Model Administrative Change Notice

| 1. Document Number: MDL-NBS-HS-000011 | 2. Revision: 03 | 3. ACN: 01 |
| 4. Title: Saturated Zone Site-Scale Flow Model | | |

Figure 1-1. Generalized Flow of Information among Reports Pertaining to Flow and Transport in the SZ

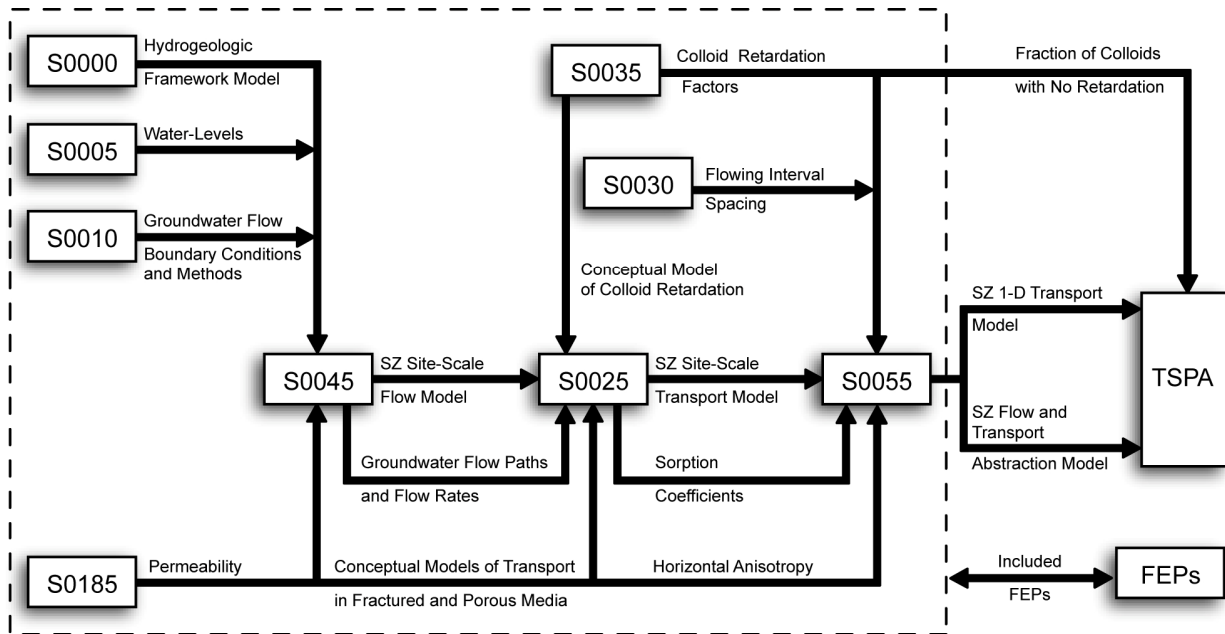
| 7. Affected Pages | 8. Description of Change: |
|-------------------|--|
| p. 1-2 | Updated Figure 1-1. |

Figure 6-10. Hydrogeologic Grid Nodes and Spacing at West-East Cross Section in the SZ Computational Grid at UTM Northing = 4,064,000 m

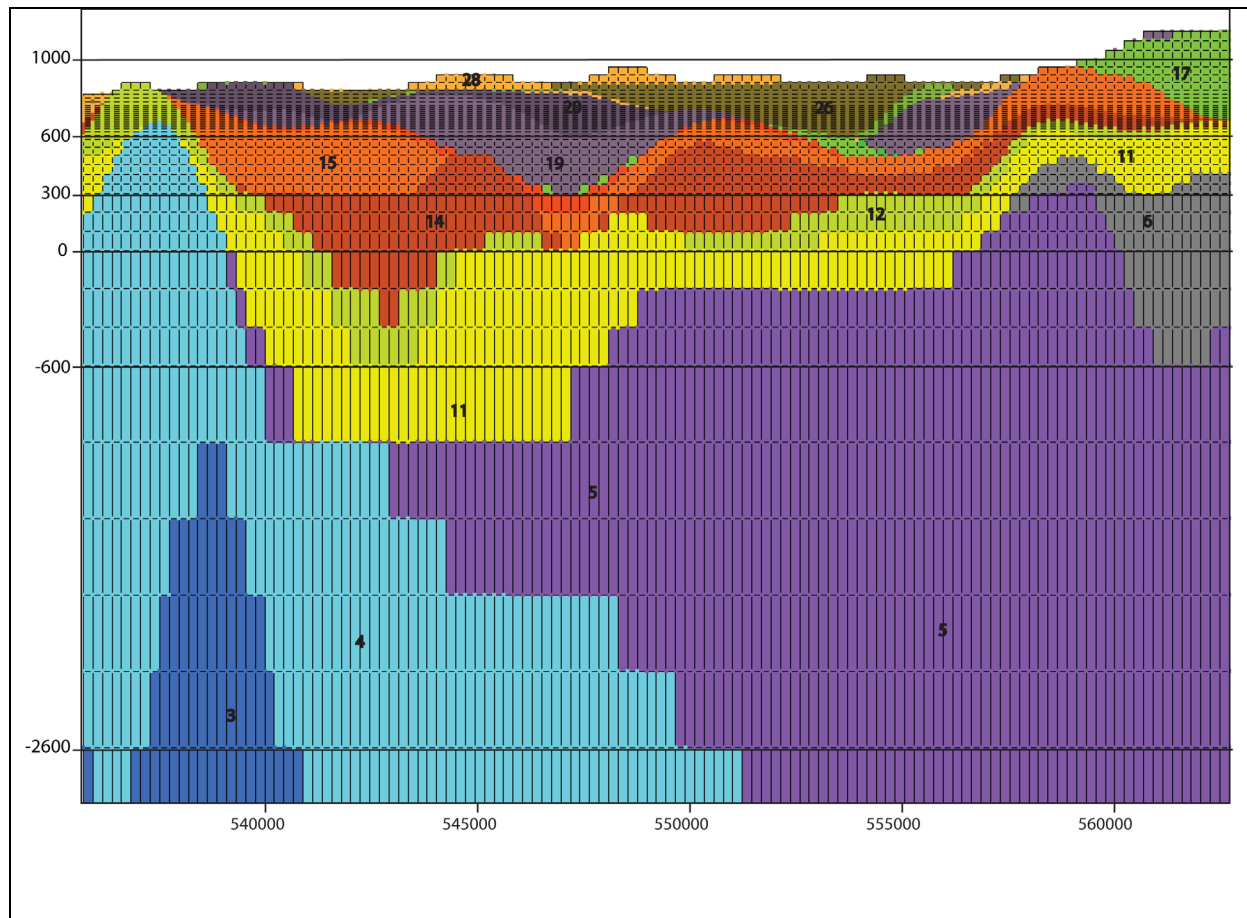
| p. 6-42 | Elevations added to Figure 6-10 per DOE comment and removed x-axis label. | | | | |

Figure 6-12. Geologic Features Included in the SZ Site-Scale Flow Model

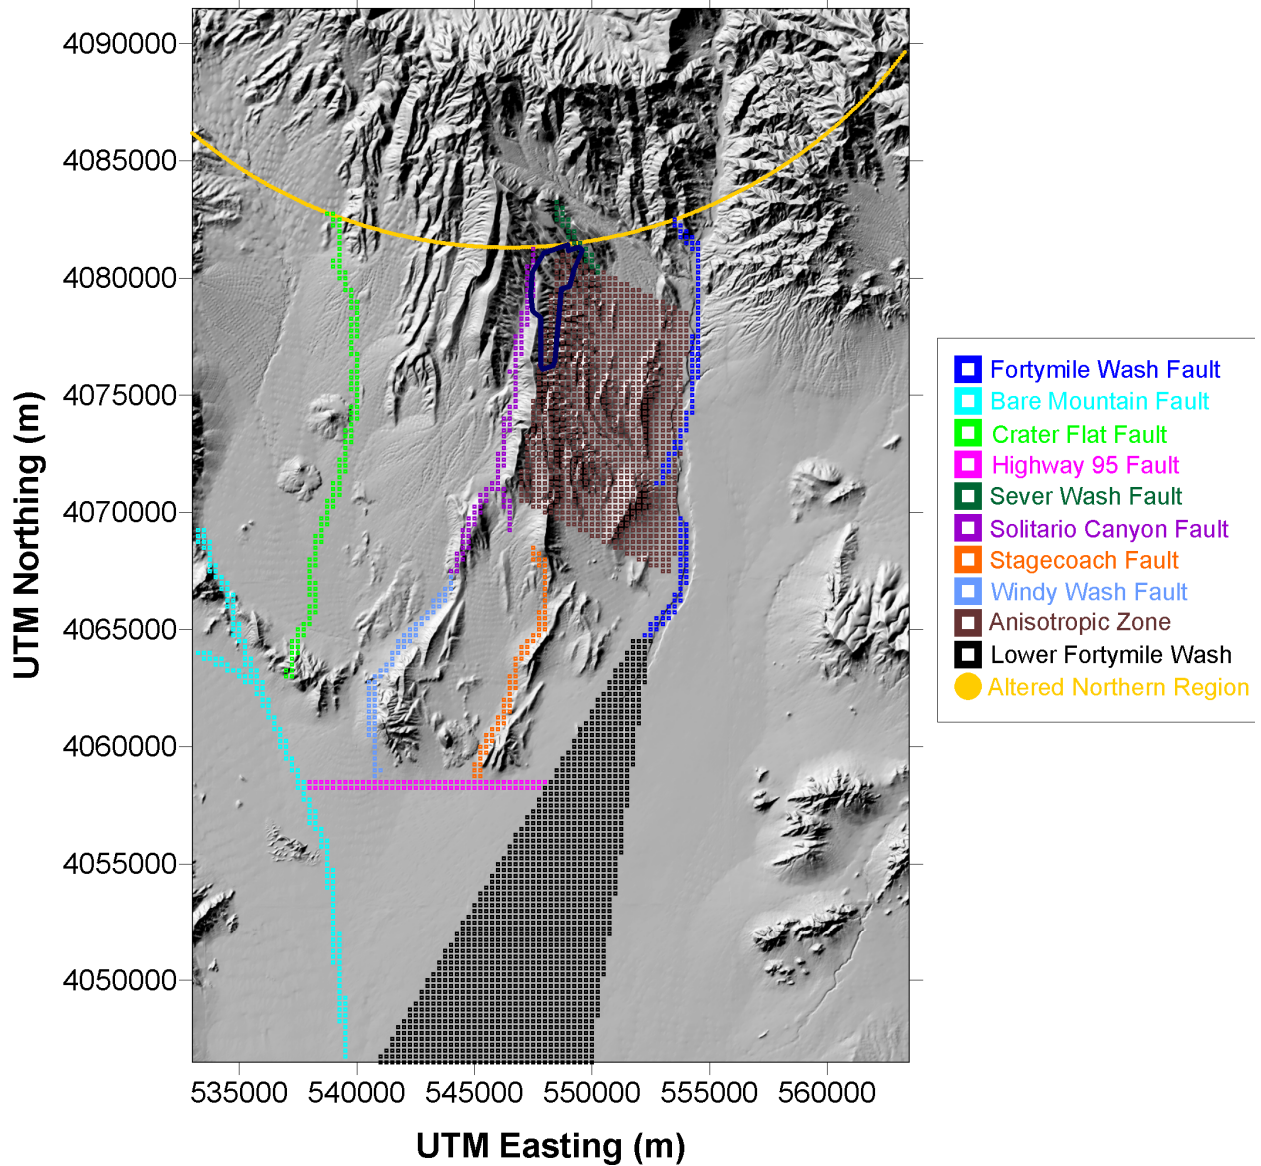
| p. 6-48 | Update Figure 6-12 caption to read “Altered Northern Region.” | | | | |
